INDESIT company

Model type:
WA6XIT

Commercial code:
F026881

Notices

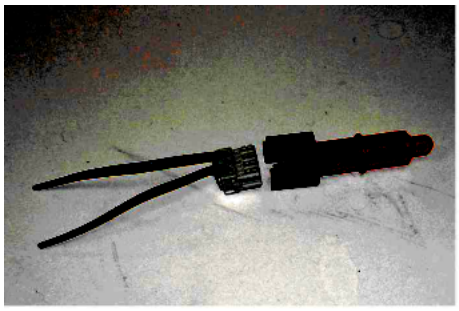
From serial number 20302.0001, the button switch NO code 088394 is used instead of the premodified switch NO+NO code 075445 (see attached illustration) and the button switch SE-NO code 063971 is used instead of the premodified switch SE-NO code 058465 (see attached illustration) on washing machine AL68XPT .
Both switches are regularly managed, therefore in case of repair the serial number of the unit must be taken into consideration.
This modification also regards the wiring code 088448 which as with all the LB 2000 models, is managed only by request, i.e. without stock, in order to always manage the interchangeable one with the last modification.
Due to the simplicity of the modification, the images of the wiring diagrams used remain the same as the IDC wiring diagrams already available on the WEB.
The modification will be also extended to other models which from time to time will be listed below.

FIG. 1

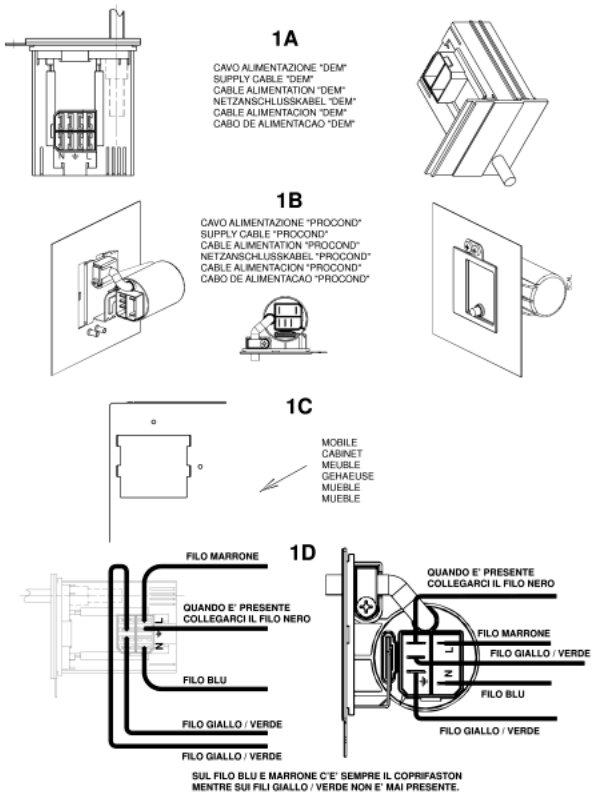
The premodification wirings, are also managed for modified products by making the connection to the terminal block of the new cable as shown in fig. 1 - 1D.
The wiring diagrams given in the Documentation remain unchanged.

IMPORTANT: the fixing / continuity screw is a specific self-scraping screw (code 092348) that ensures earth continuity between the filter and the unit. The same screw must be refitted in order to guarantee machine conformity.

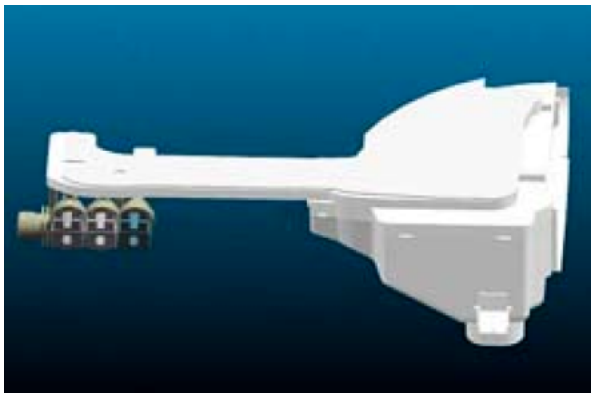
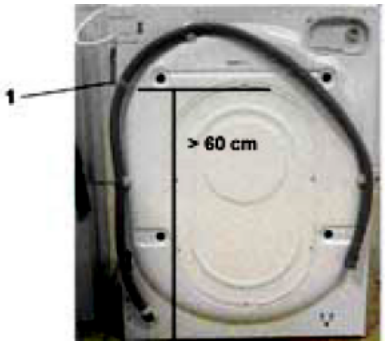
- EEPROM (the OKO system requires a new setting of load timing parameters). THE NEW EEPROMS REPLACE ALL THE ONES CODED PREVIOUSLY.
- BOWL (hopper tube hole shifted forwards);
- DETERGENT LOADING TUBE (see fig. 1);
- PRESSURE SWITCH (changed levels);
- OKO PUMP BOWL BLOWER + BALL (see fig. 2A, 2B and 2C);
- CONDUCTIVITY SENSOR (if provided, it is shorter than the premodification item);
- DRAIN PUMP (without detergent collecting tube connection);
- HOPPER (shifted in front of detergent loading tube connection). Fig. 3A post-modification. Fig. 3B premodification);
- AIR TRAP (different shape);
- PRESSURE SWITCH TUBE (different length);
- DRAIN TUBE STOP (specific);

In particular, the OKO system consists of a spherical plastic component inserted in the tube that connects the bowl to the drain pump (see fig.2 A).
At the beginning of each wash cycle the washing machine fills water for 10 seconds and activates the drain pump for 2 seconds. In this way, the water level in the bowl is different from that in the drain tube; this difference increases the thrust of the ball upwards, closing the bowl-pump connection tube hermetically (see fig. 2D).
This system has the double advantage of:

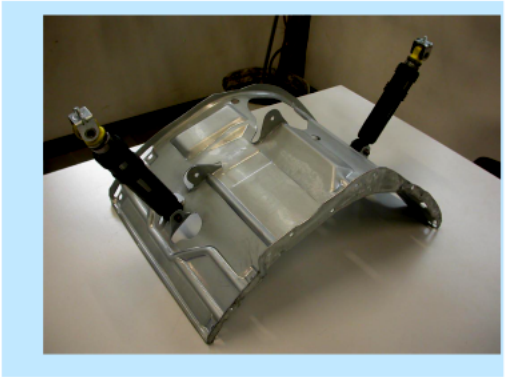
From serial no. 40427.0001, shock absorbers have been fixed to the tank unit cradle with two 11 mm pins code C00110163 (see fig. 01 and 02 enclosed) in place of the 8 mm screws code 093750 and relevant locking nuts code 030443, on all washing machines and dryers produced in the Comunanza factory.
The items affected by this modification are:
1) The cradles have the same Service code, as they can be used in place of the new ones after widening the shock absorber fixing holes to a diameter of 10 mm.

To remove the shock absorber from the tank, first extract the pin with a few hammer taps (see fig.03) until it is aligned with the tank bracket and then pull it out with a pair of pliers (see fig. 04).
(To refit the shock absorber use a new pin. Insert the pin until the toroidal edge is aligned with the bracket.)
